SERVICE BULLETIN

M-1373

2014 TOURING ABS BRAKE LINE - SAFETY RECALL 0157

Figure 1. ABS Brake Line Cable Straps

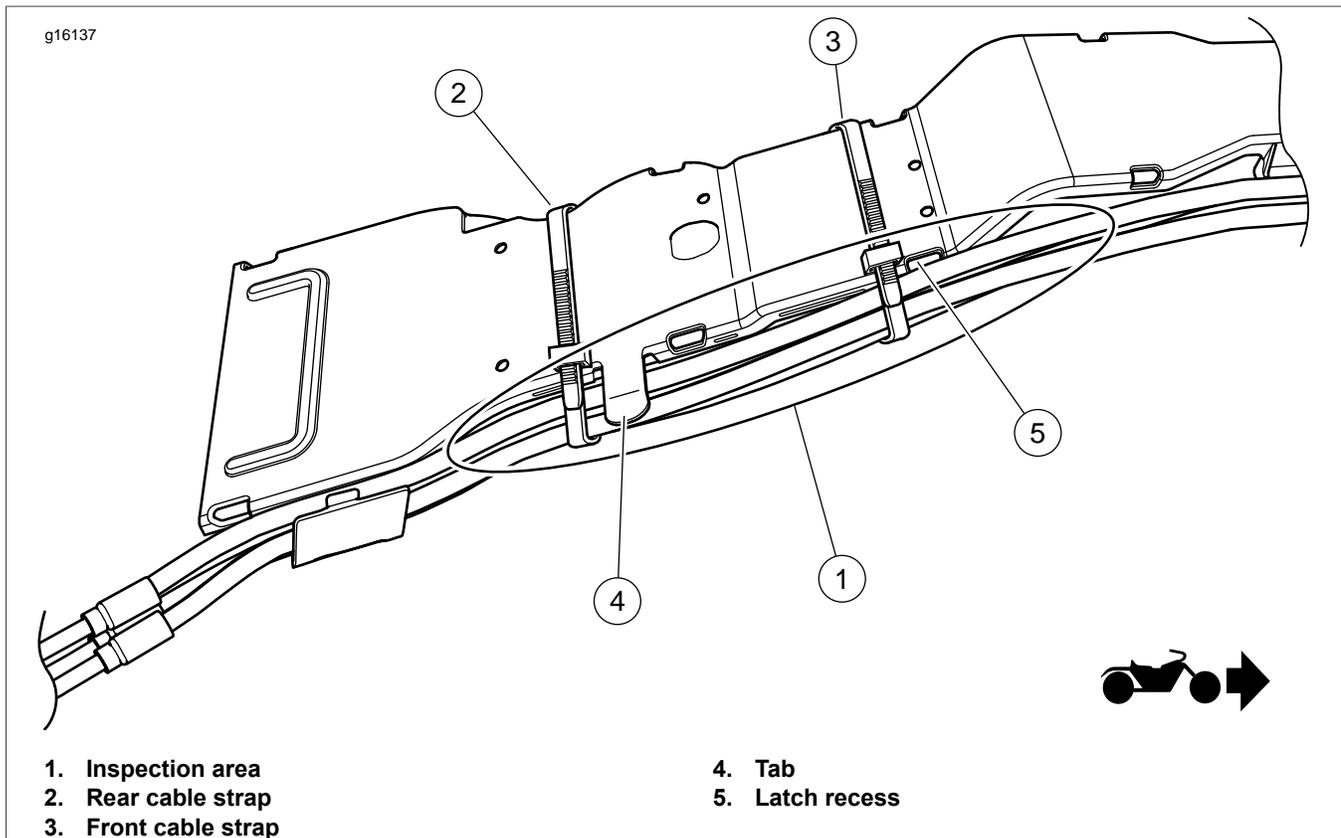
The affected motorcycles may have been assembled with a front brake line in a position where it could become pinched between the fuel tank and the frame, either at original assembly or in subsequent service activity. If a pinched brake line remains undetected it could cause front brake fluid pressure to increase while riding, possibly resulting in a front wheel lock-up.

1. Confirm the motorcycle is involved and the recall is open.
2. Remove the seat and fuel tank. See the service manual.
3. See Figure 1. Inspect brake line routing along the wire trough. Verify that the lines are secured by two cable straps (2, 3) as shown. Motorcycles built October 14, 2013 and later will have the rear cable strap (2) already installed. Installed cable straps may be black or white in color. Both are acceptable.

4. If lines are not secured by cable straps:
 - a. Inspect lines for damage in area (1).
 - b. If line is damaged, refer to Table 1 to determine if replacement is necessary. If line replacement is required, see the service manual. The **new** line can be taken from dealer inventory or ordered using the included order form.

- c. Verify that lines are properly routed under tab (4).
 - d. Secure lines with one or two **new** cable straps (2, 3) (Part no. 10039) as required. Locate rear cable strap (2) within 1/2 in (13 mm) rearward of tab (4). Locate front cable strap (3) at or near latch recess (5).
